**DOCKET ITEM #7****Development Special Use Permit #2017-0016****3300 King Street – TC Williams High School****Parker-Gray Stadium Modernization**

Application	General Data	
Project Name: TC Williams High School Parker-Gray Stadium Modernization	PC Hearing:	October 2, 2018
	CC Hearing:	October 13, 2018
	If approved, DSUP Expiration:	October 13, 2021
	Plan Acreage:	23.68 acres (1,031,366 sf)
	Limits of Disturbance:	.97 acres (41,167 sf)
Location: 3330 King Street Parcel Address: 3300 King Street	Zone:	R-20
	Proposed Use:	Public School
	Dwelling Units:	N/A
	Gross Floor Area:	N/A
Applicant: Alexandria City Public Schools	Small Area Plan:	Taylor Run / Duke Street Small Area Plan
	Historic District:	N/A
	Green Building:	N/A

Purpose of Application
To construct new accessory buildings and perform associated site improvements associated with the stadium including pedestrian, track and field site improvements, sound system upgrades, site lighting, and athletic field lighting.
Special Use Permits and Modifications Requested:
<ol style="list-style-type: none">1. Amendment to an existing Development Special Use Permit with Site Plan to construct accessory structures and perform site improveme

Option A:

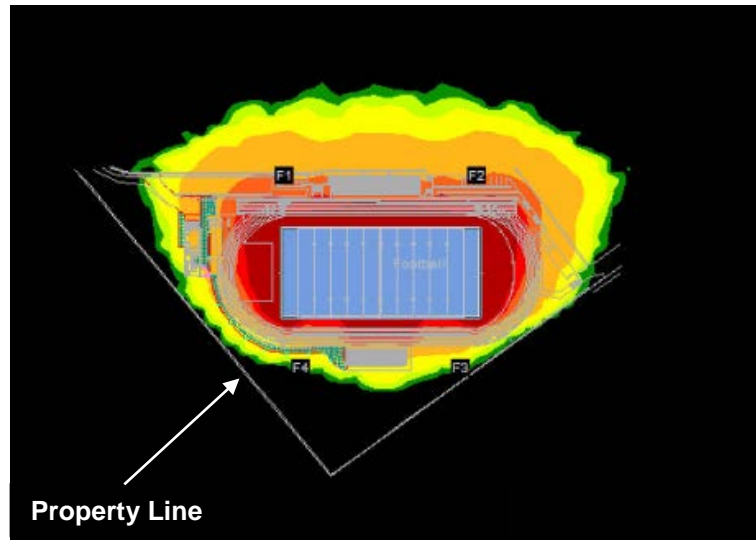
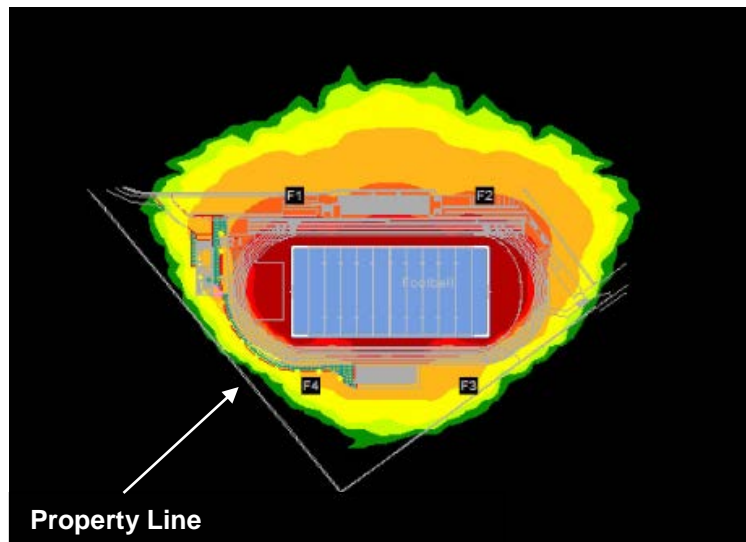
Compared to Option B, the overall light pattern is tighter and more precisely aimed. Glare impact is less along the west and south property lines.
